Ref: 04257

19 July 2017

PARK BEACH RESIDENCES
DEVELOPMENT APPLICATION 0902/17 DA
AMENDMENT TO DEVELOPMENT APPLICATION

This letter is a request by the applicant to amend the above development application prior to determination of the application. This letter also summarises responses to 'stop the clock' requests for information issued by Council, and attaches amended information submitted by the applicant.

Drawing
SITE PLAN

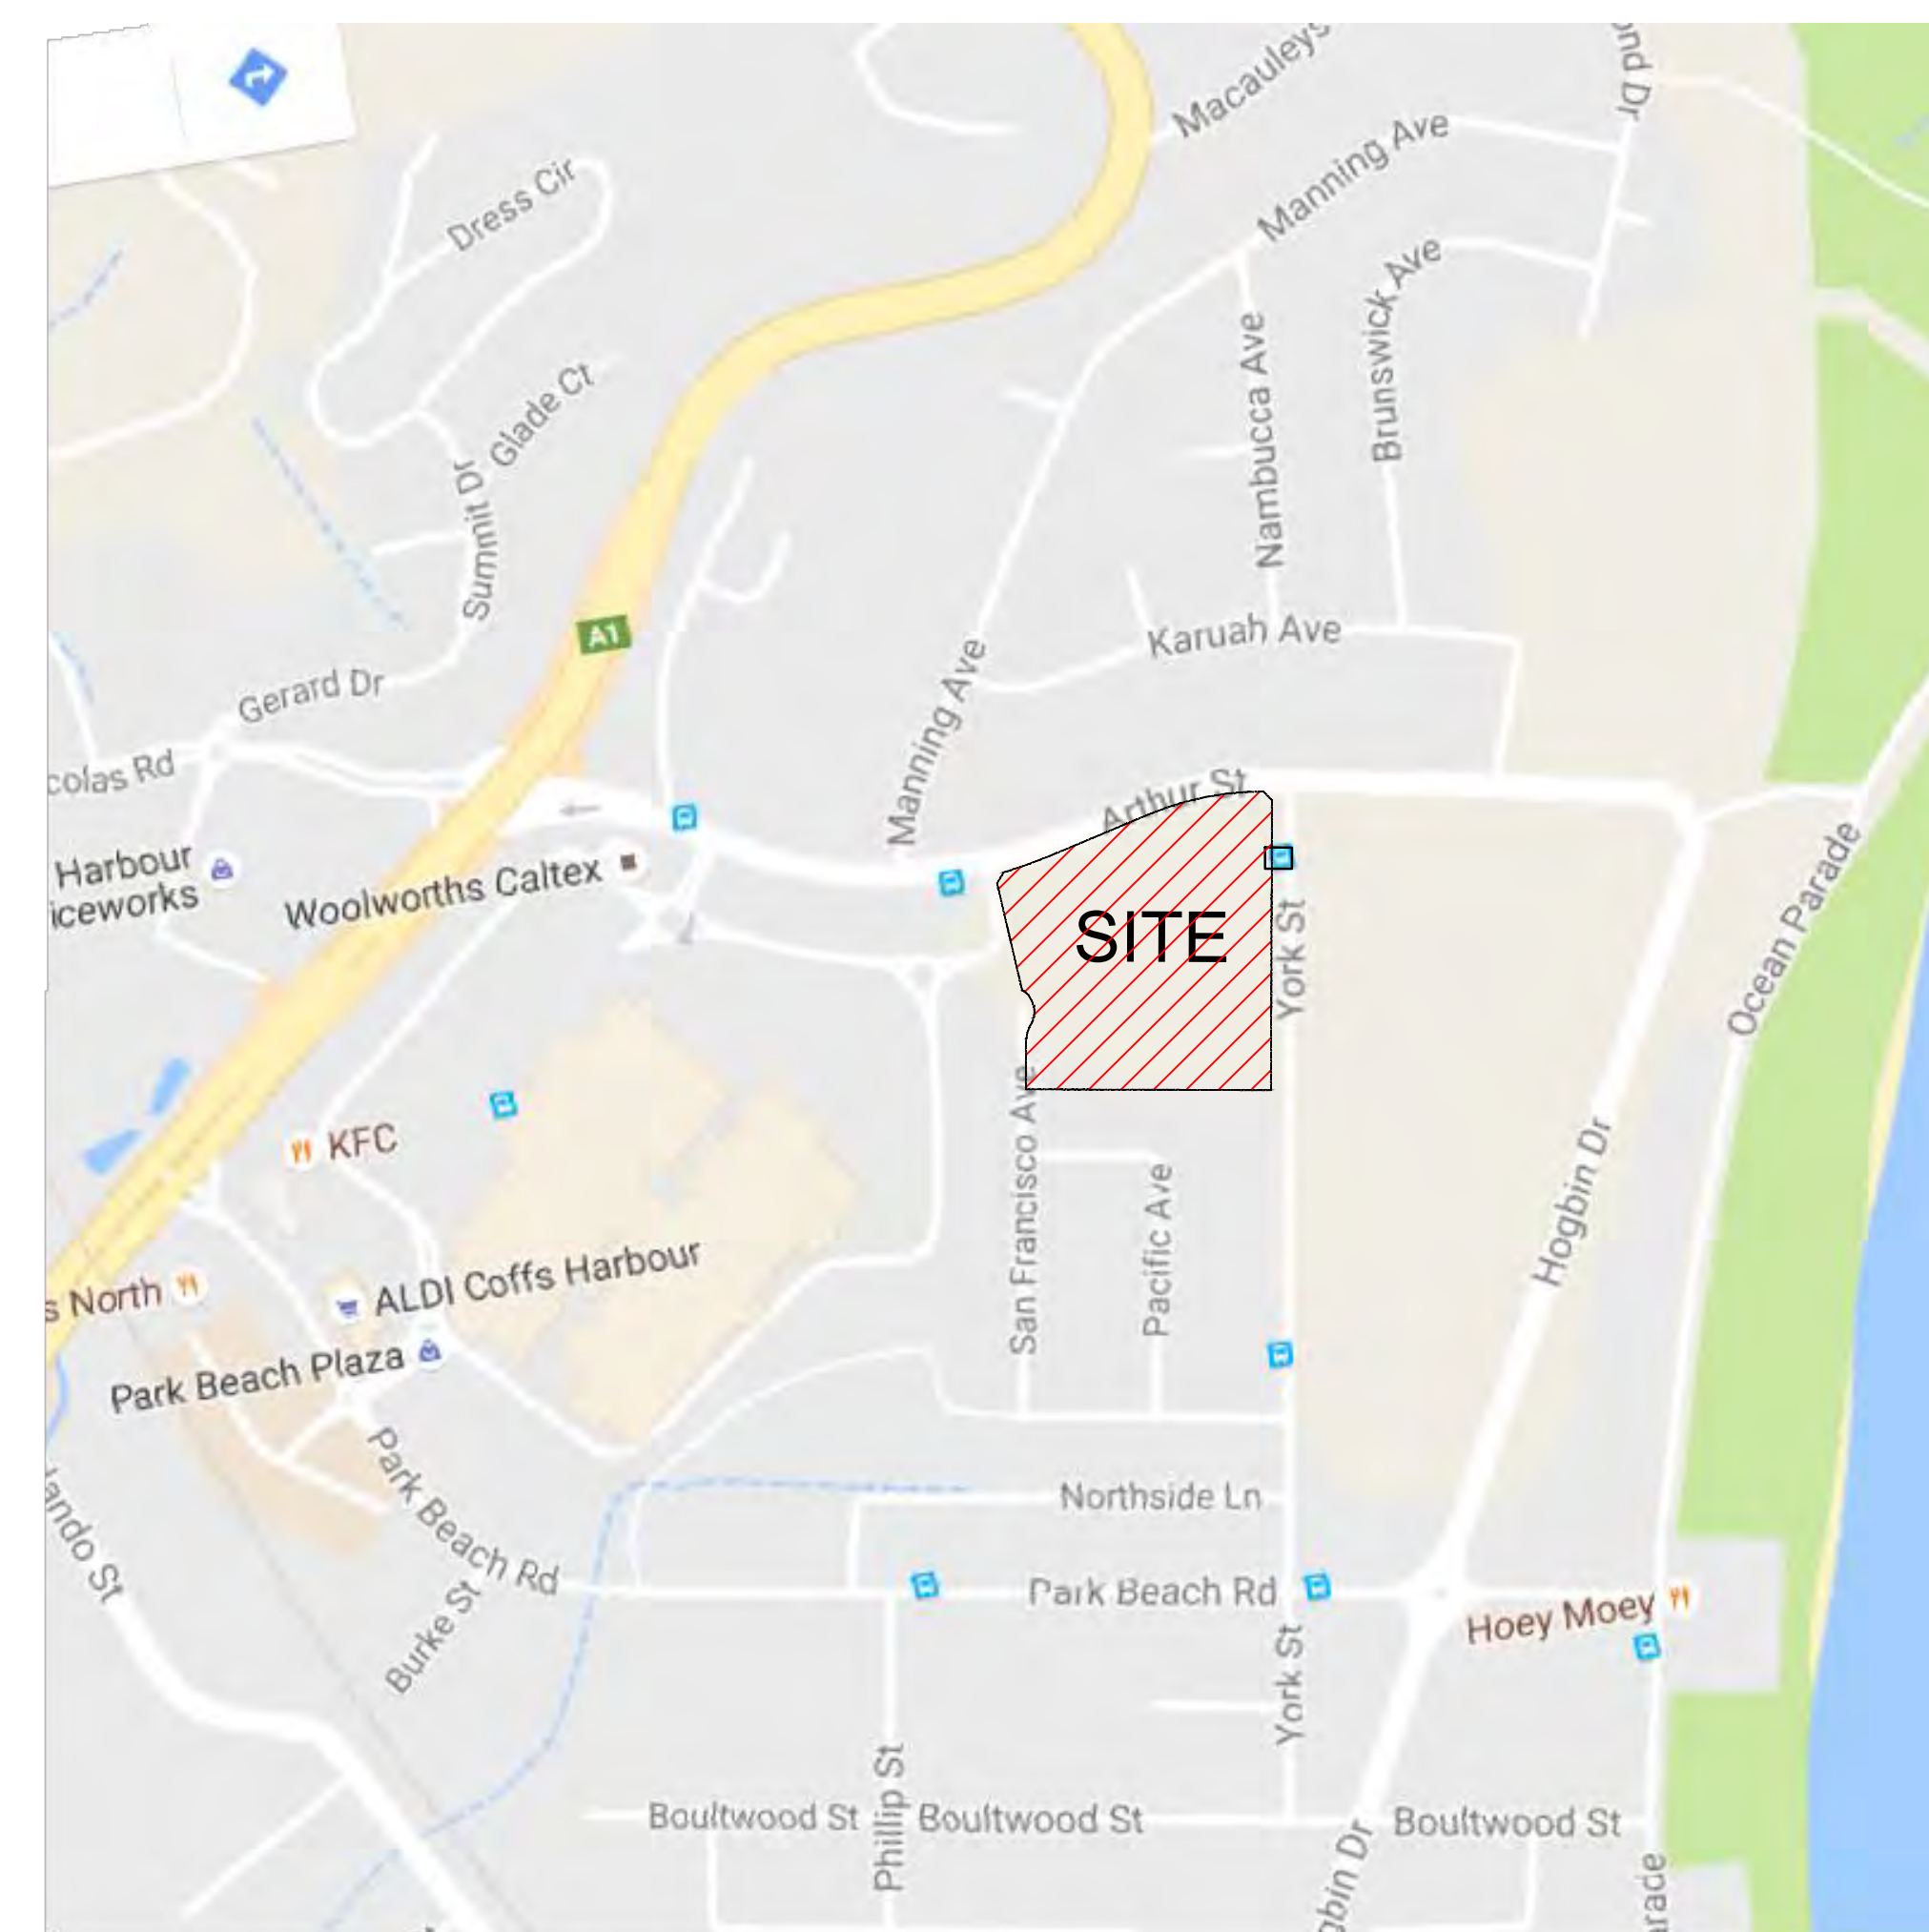
0m 5 10 25 35m SCALE: 1:500		
9	Road access to San Francisco Avenue deleted, Carparking modified, Footpath added	19.07.17
8	DA Issue	20.04.17
7	Preliminary Issue for review & comment	12.04.17
6	Preliminary Issue for review & comment	30.03.17
5	Pre-DA Council Meeting	06.03.17
4	Preliminary Issue	08.02.16
3	Preliminary Issue	19.01.16
2	Preliminary Issue	19.12.16
1	Preliminary Issue	05.12.16
No.	Amendment	Date

Drawing
GROUND FLOOR PLAN - OVERALL

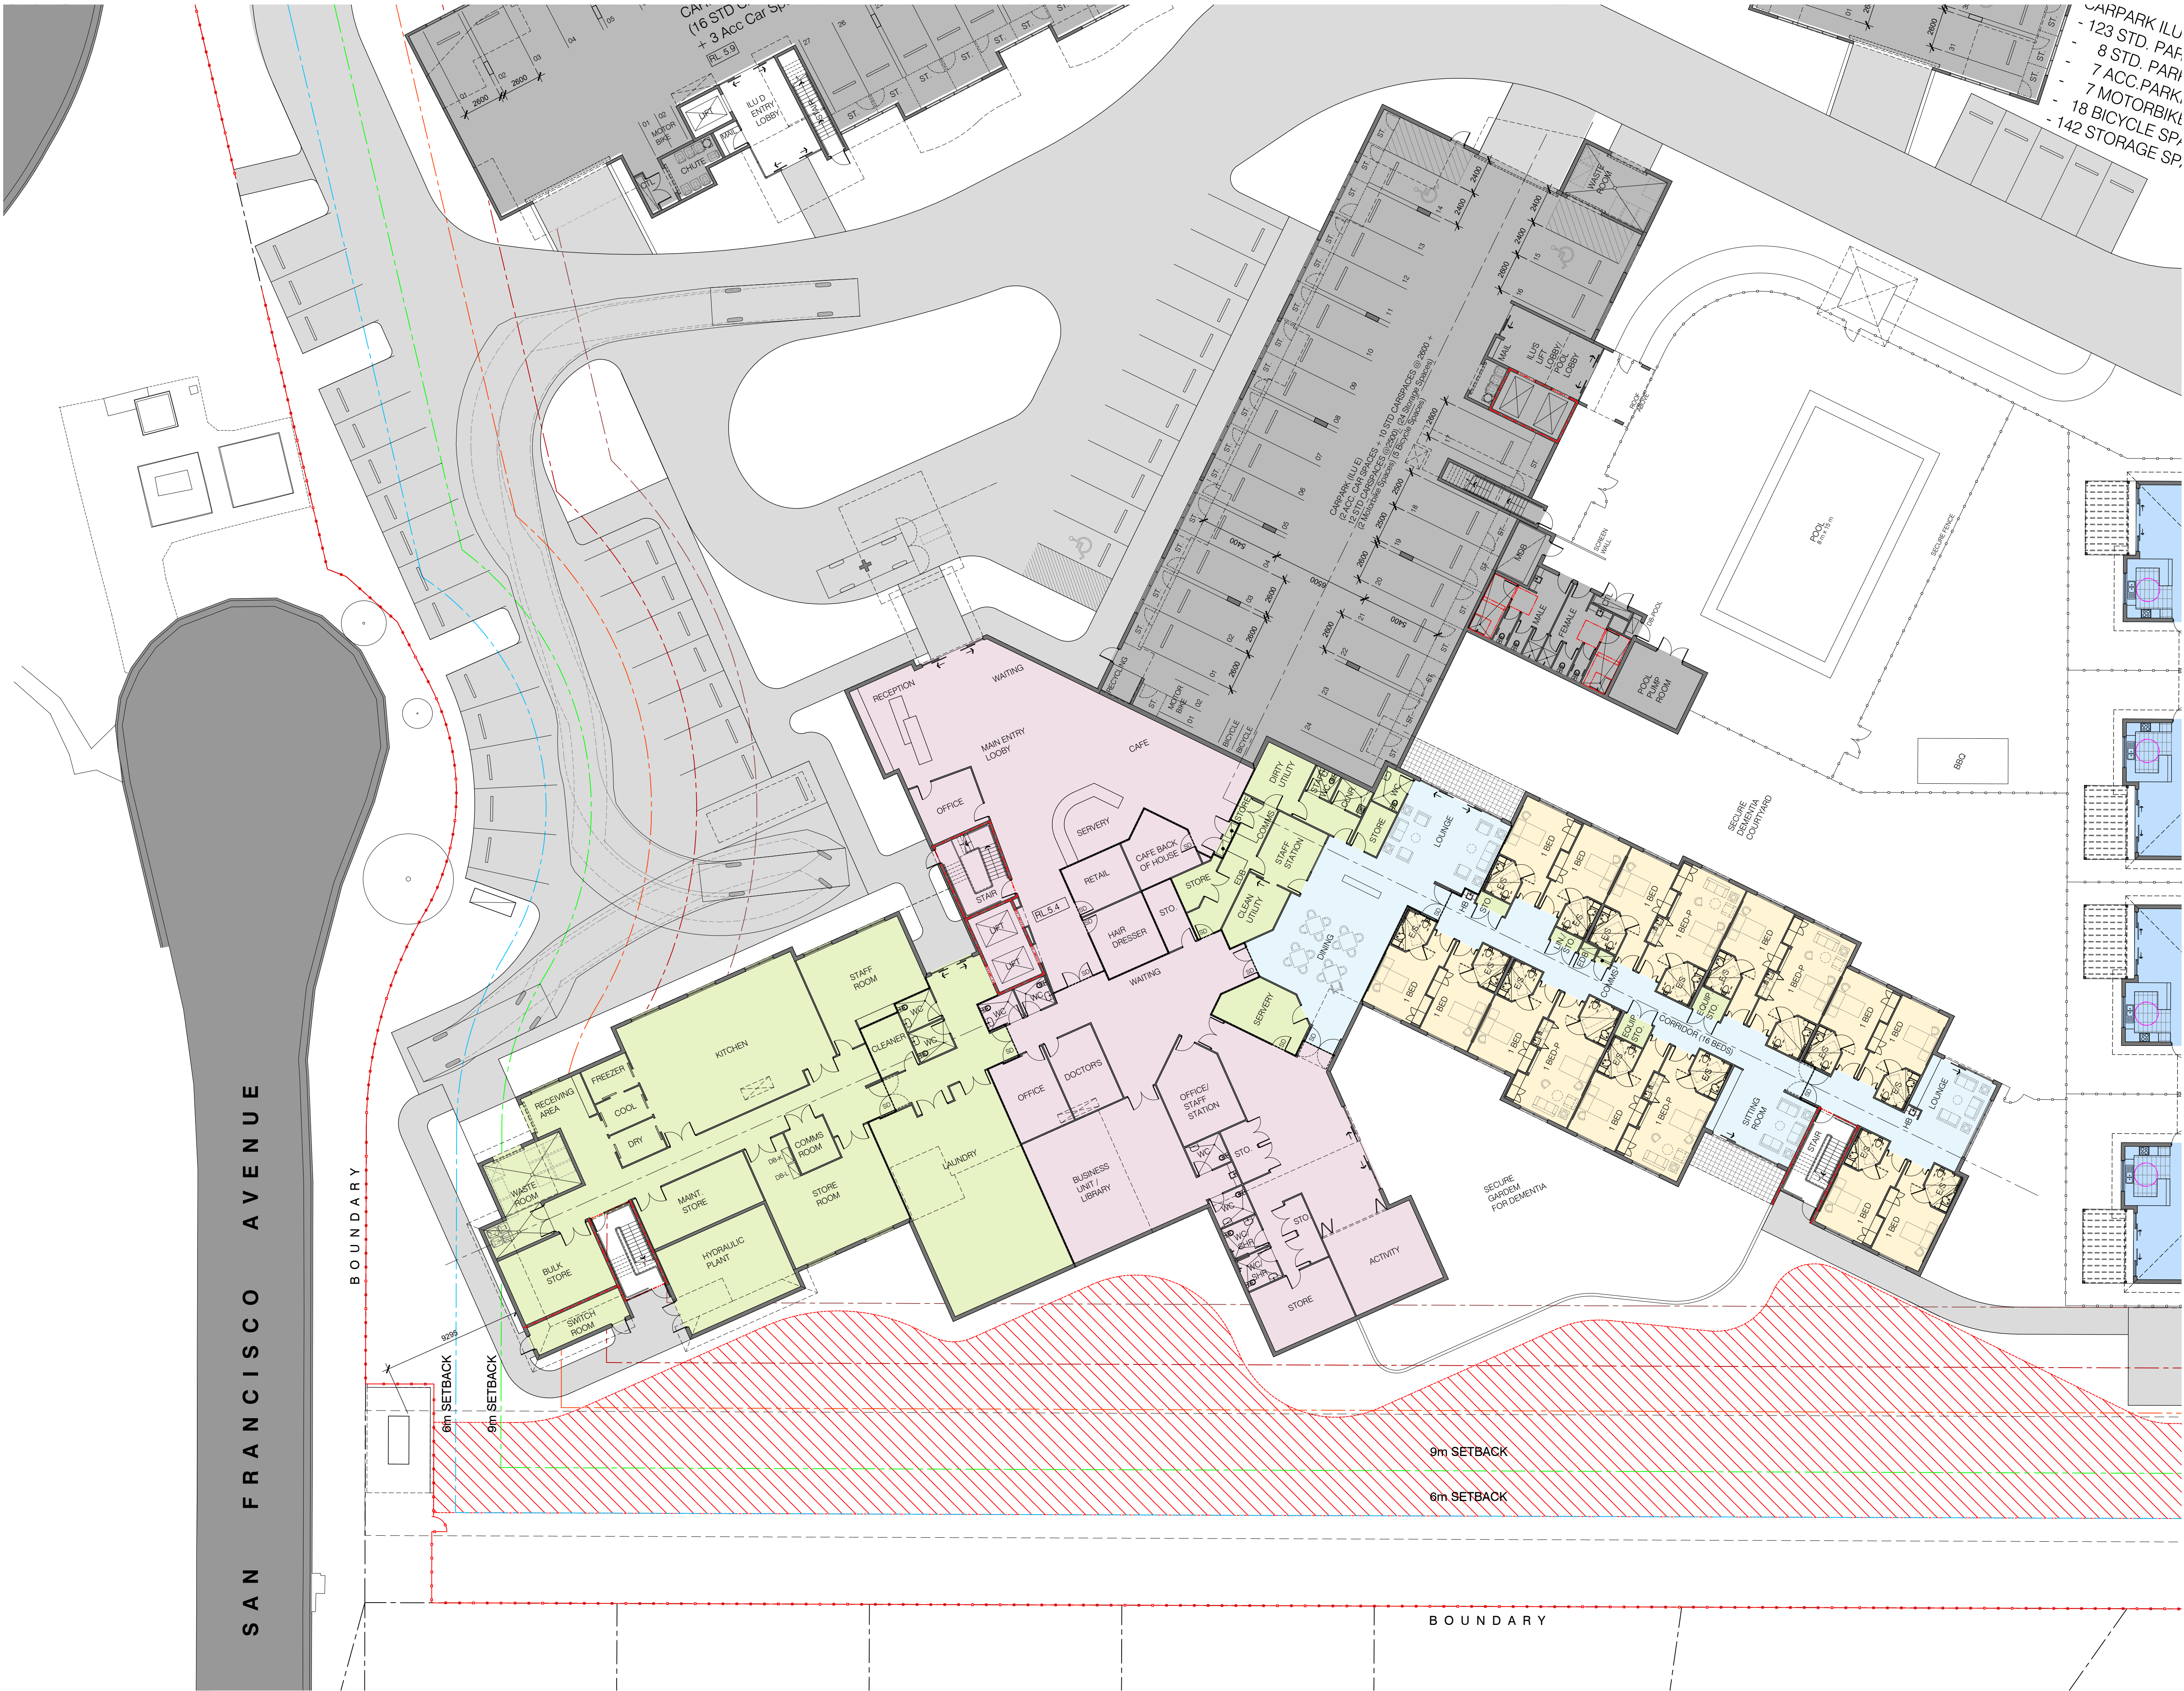
11	Road access to San Francisco Avenue deleted. Carparking modified, Footpath added	19.07.17
10	- Footpath modified to 1800mm width - Porte cochere driveway widened to allow passing bay - Accessible carparking modified to allow for 2.4m shared zone - Footpath to 2 x RCF carpark added - Gate deleted @ San Francisco Avenue - Gate added @ Main entry @ York Street	14.06.17
9	Additional turning vehicle diagrams added	07.06.17
8	DA Issue	20.04.17
7	Preliminary Issue for review & comment	12.04.17
6	Preliminary Issue for review & comment	30.03.17
5	Pre-DA Council Meeting	06.03.17
No.	Amendment	Date

Drawing
GROUND FLOOR PLAN - RCF

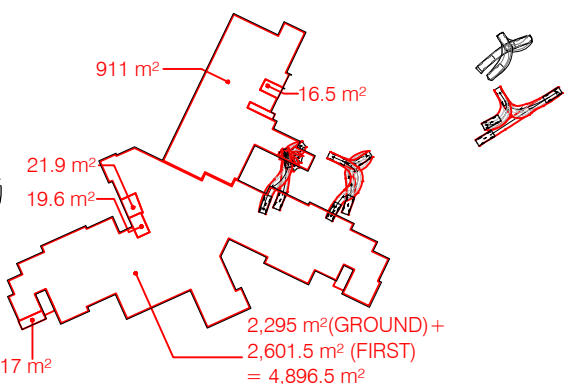
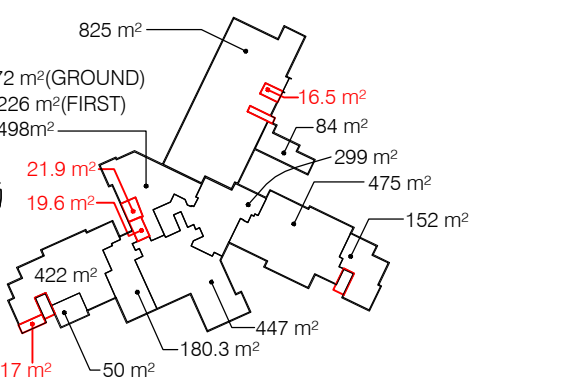
11	Road access to San Francisco Avenue deleted. Carparking modified, Footpath added	19.07.17
10	- Footpath modified to 1800mm width - Porte cochere driveway widened to allow passing bay - Accessible carparking modified to allow for 2.4m shared zone - Footpath to 2 x RCF carparks added - Gate deleted @ San Francisco Avenue - Gate added @ Main entry @ York Street	14.06.17
9	DA Issue	20.04.17
8	Preliminary Issue for review & comment	12.04.17
7	Preliminary Issue for review & comment	30.03.17
6	Preliminary Issue for review & comment	22.03.17
5	Pre-DA Council Meeting	06.03.17
No.	Amendment	Date
